ZONING CHANGE REVIEW SHEET**CASE:** C14-2017-0156**P.C. DATE:** January 9, 2018**ADDRESS:** 1105 Airport Boulevard**TOTAL AREA:** 9.86 Acres**DISTRICT:** 3**OWNER:** SL Shady Lane, LP (John Kiltz)**AGENT:** McLean & Howard, LLP (Jeffrey S. Howard)**EXISTING ZONING:** GR-MU-CO-NP**PROPOSED ZONING:** GR-MU-CO-NP, to change a condition of zoning

NEIGHBORHOOD PLAN AREA: Govalle-Johnston Terrace**TIA:** See attached memorandum**WATERSHED:** Boggy Creek**CAPITOL VIEW CORRIDOR:** No**DESIRED DEVELOPMENT ZONE:** Yes**SUMMARY STAFF RECOMMENDATION:**

EXHIBIT A

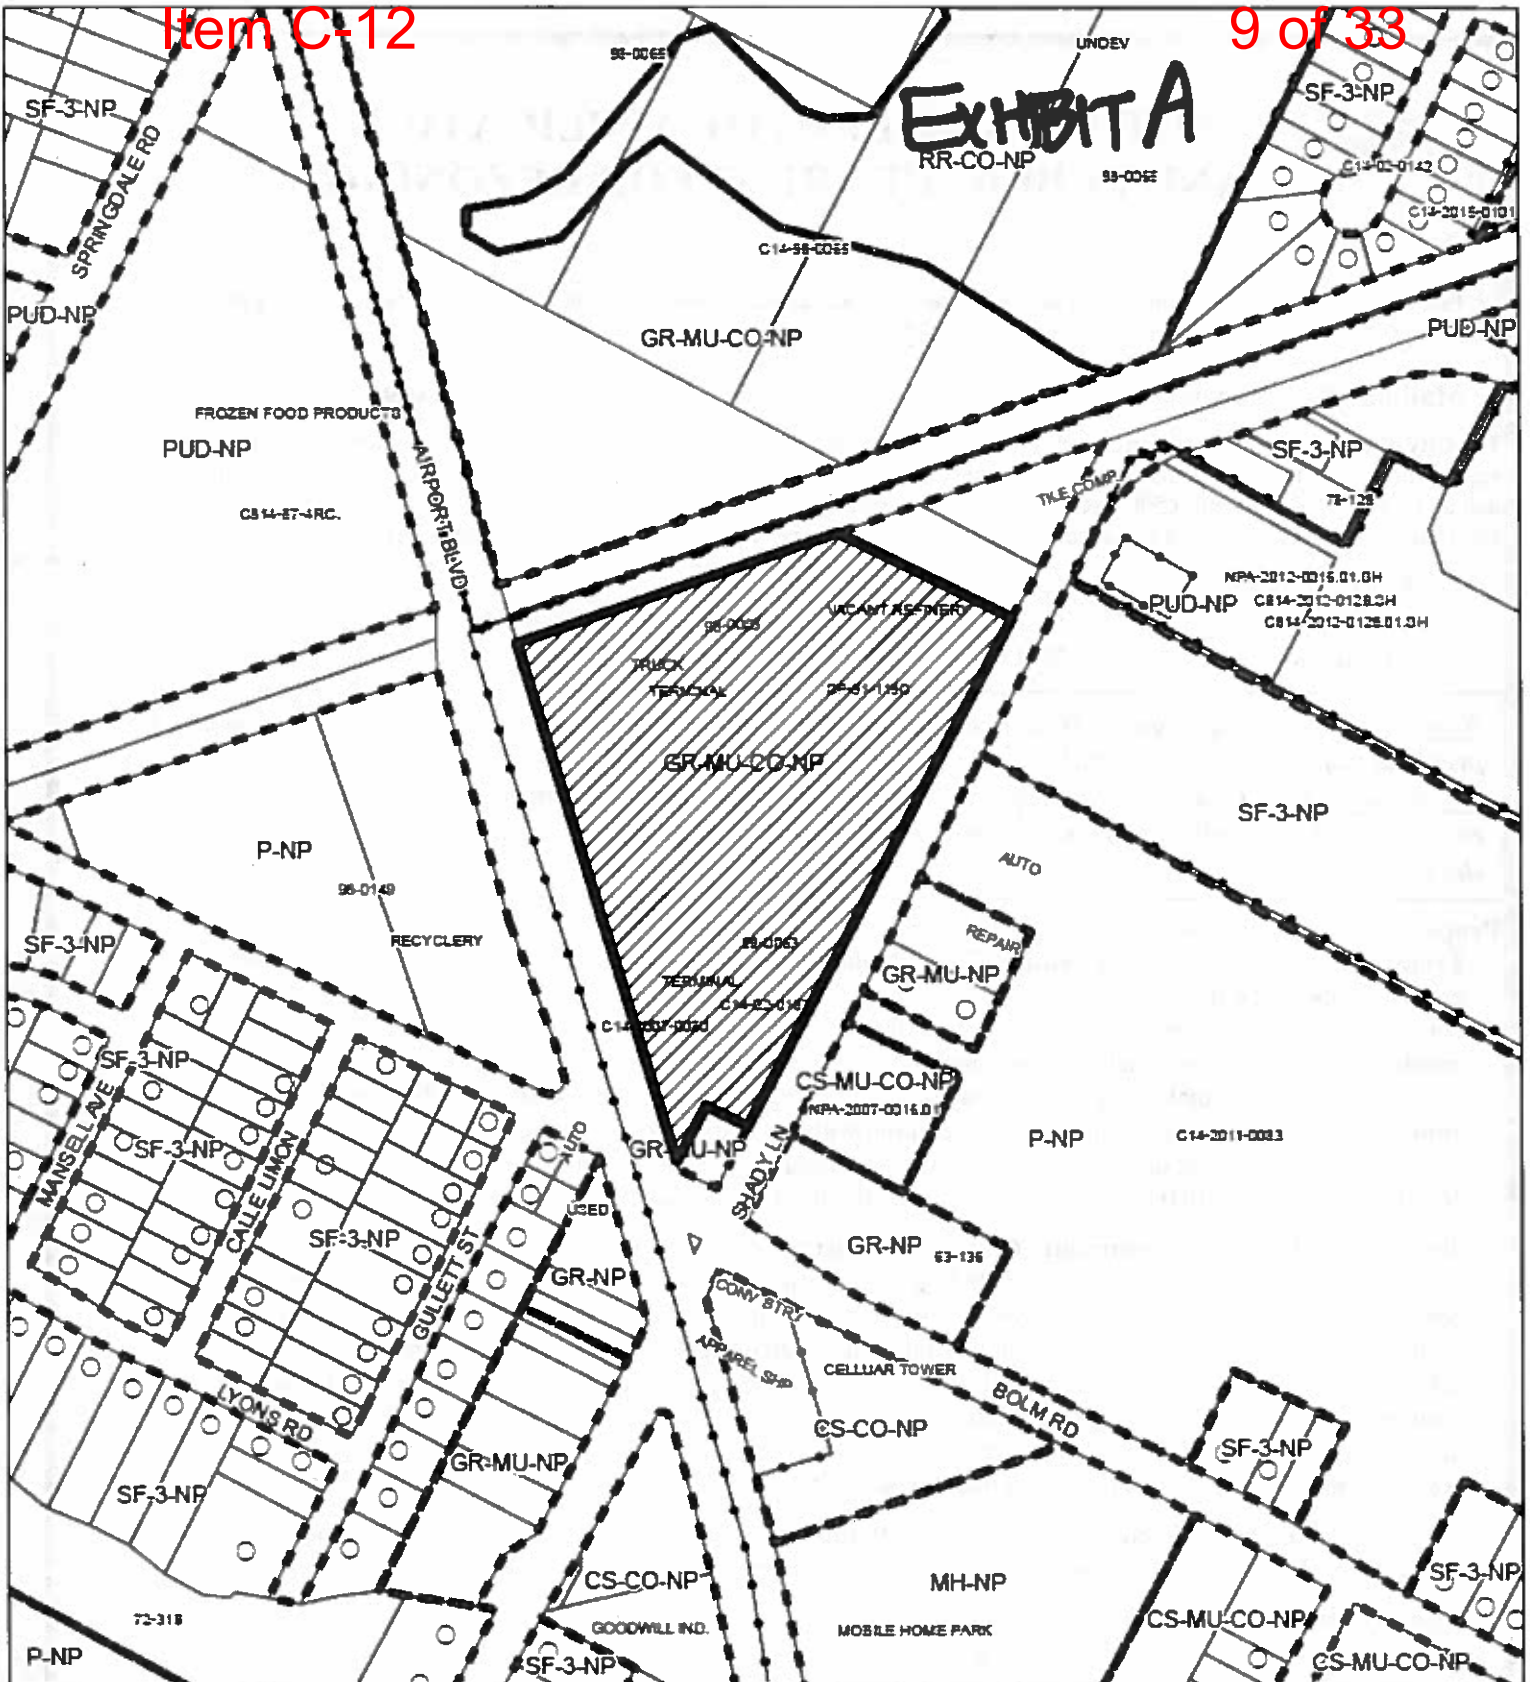
The subject property is located north of the intersection of Airport Boulevard and Shady Lane. The site is undeveloped and zoned GR-MU-CO-NP. An undeveloped outparcel that is not part of the rezoning request (but owned by the same owner) is directly at the intersection and is zoned GR-MU-NP. The rezoning tract surrounds this outparcel and extends to its northern boundary of at the Southern Pacific railroad right-of-way (ROW). Across the ROW to the north is an undeveloped property zoned GR-MU-CO-NP. Also to the north, but south of the ROW is a property zoned GR-MU-CO-NP that is developed with an existing nonconforming use of Construction sales and services. Across Shady Lane to the northeast is the ThinkEAST Planned Unit Development (PUD). The PUD is partially developed with office and multifamily uses. East across Shady Lane are a mix of land uses. From north to south (ending at Airport Boulevard) are properties zoned SF-3-NP, P-NP, GR-MU-NP, CS-MU-CO-NP, and GR-NP. These tracts are occupied, respectively, with a vacant residential use, Govalle Neighborhood Park, business support services, multifamily residential, art workshop, and undeveloped land uses. The SF-3-NP property with the vacant residence is currently under City review for a rezoning request to MF-4-NP (City File # C14-2017-0094). Southeast of the rezoning tract, across Bolm Road and Shady Lane are properties zoned CS-CO-NP occupied by convenience store/gas station and convenience self-storage land uses. Southwest of the rezoning tract, across Airport Boulevard, are properties zoned GR-NP, GR-MU-NP, and SF-3-NP. These are occupied, respectively, with automotive sales, automotive repair, and single family land uses. West of the subject property, across Airport Boulevard, is property zoned P-NP that was previously used for general warehousing, manufacturing and distribution when the East Austin Tank Farm area was active. The site is vacant, with only paved areas remaining. Also west of the property, across both Airport Boulevard and the railroad ROW is land zoned P-NP that is developed with a mix of commercial and limited industrial uses, including a brewery, event center, restaurant and more. Also to the west, across the railroad ROW is undeveloped land zoned GR-MU-CO-NP. *Please refer to Exhibits A and B (Zoning Map and Aerial View).*
